**Cambridge
Crossing**

| Parcel G

LAB BUILDING - DESIGN REVIEW REVISIONS

④ RAISE SOUTH PARAPET - PROPOSED

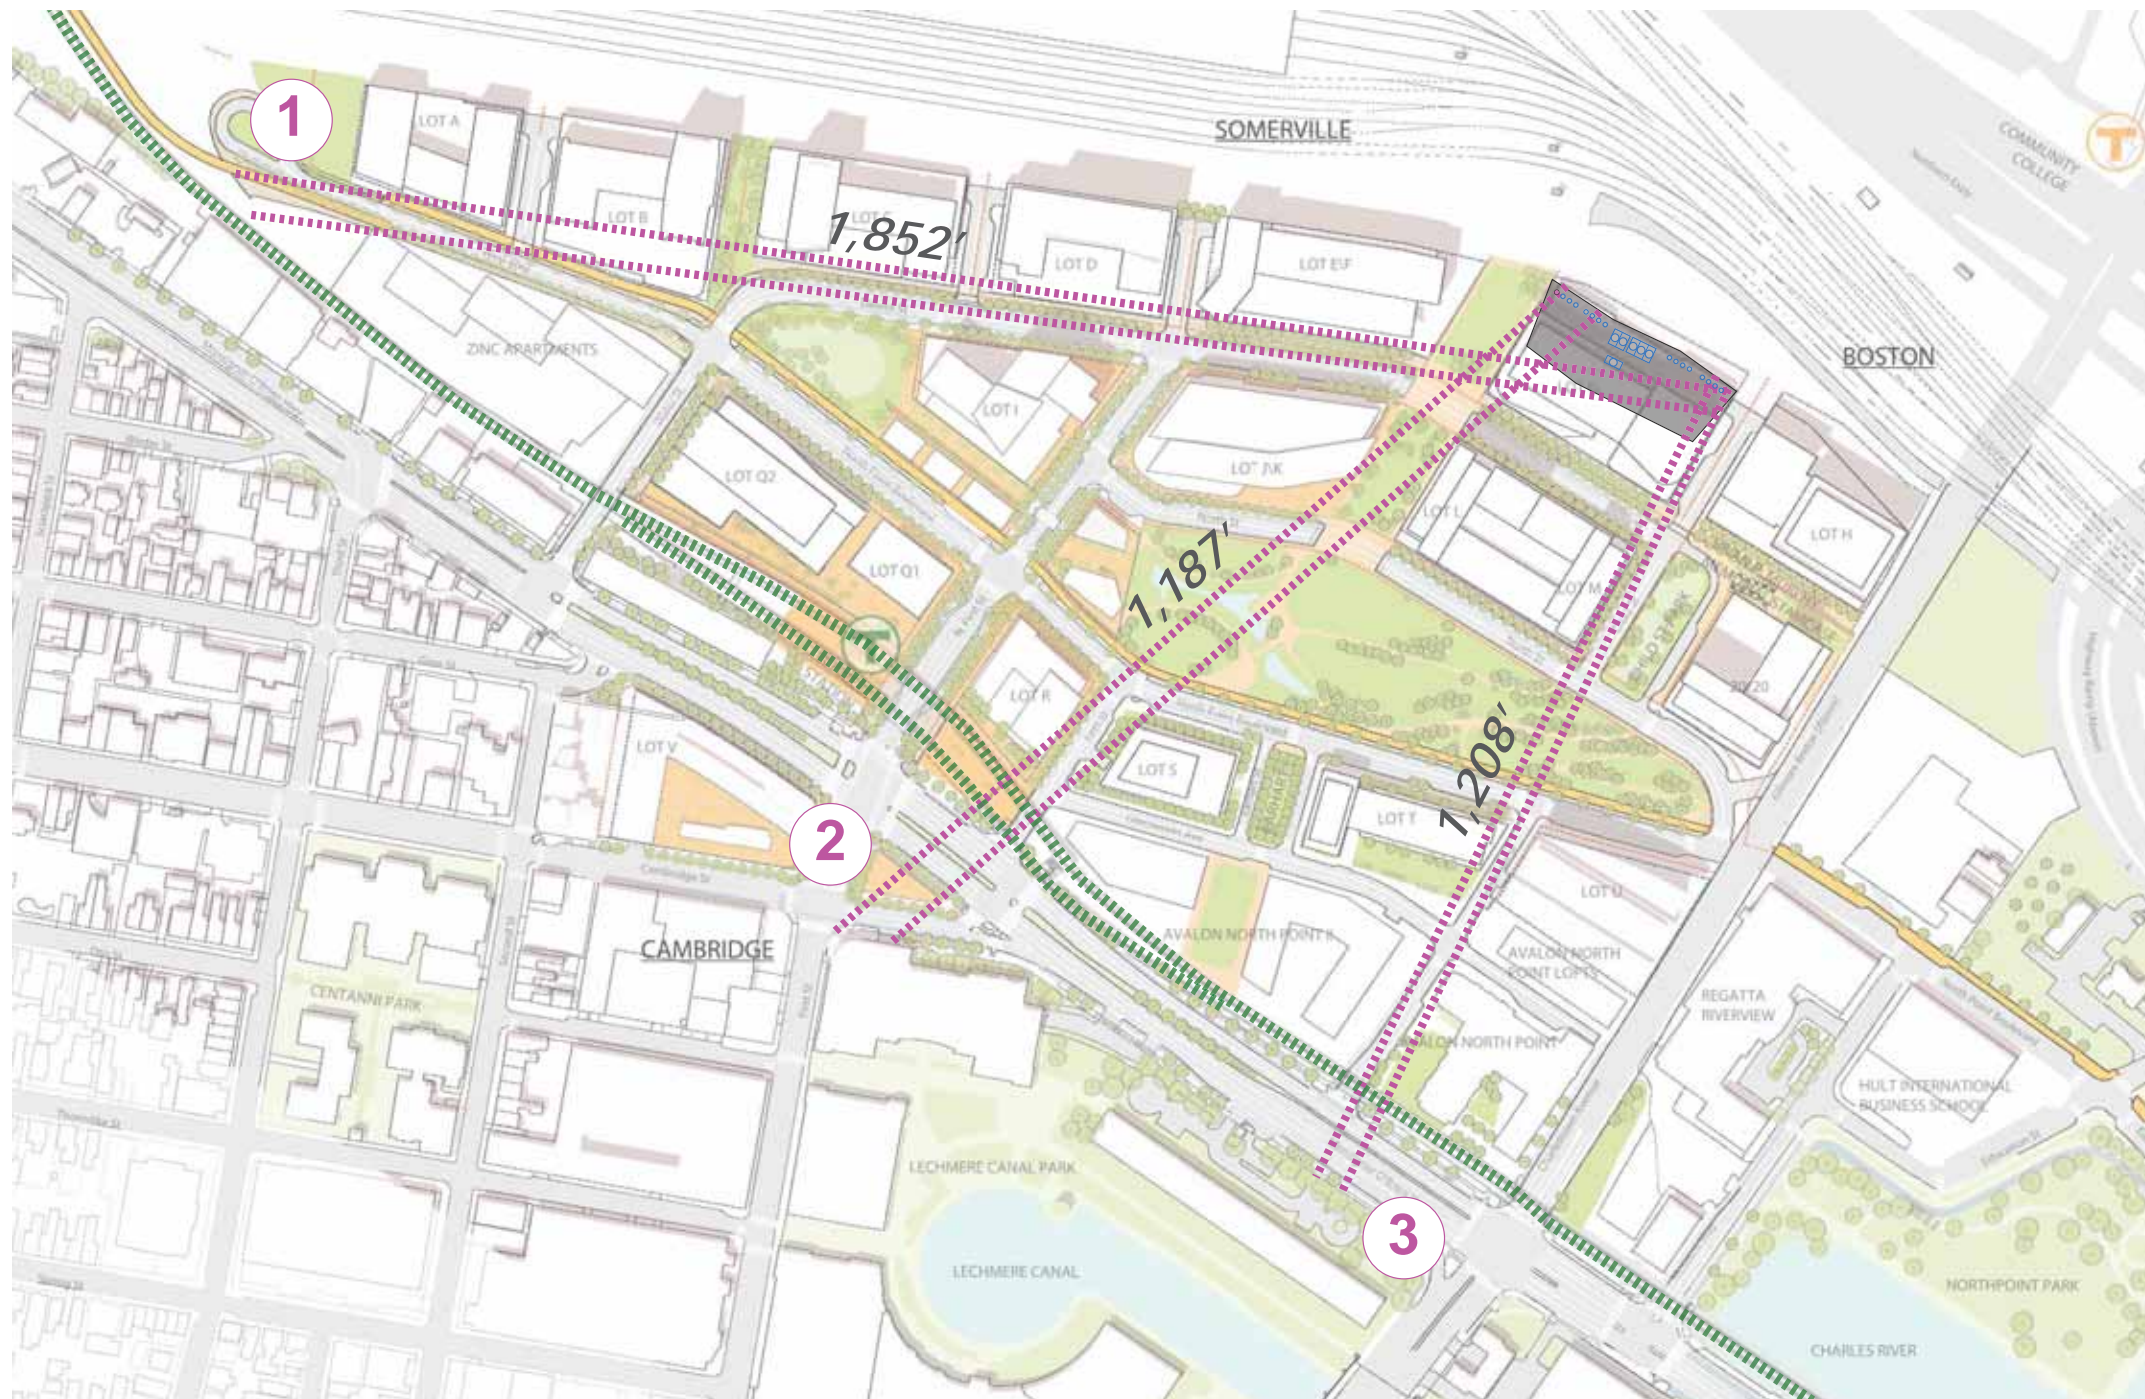
- Raise south parapet to screen added equipment
- Height of north parapet unchanged
- Equipment not visible from grade
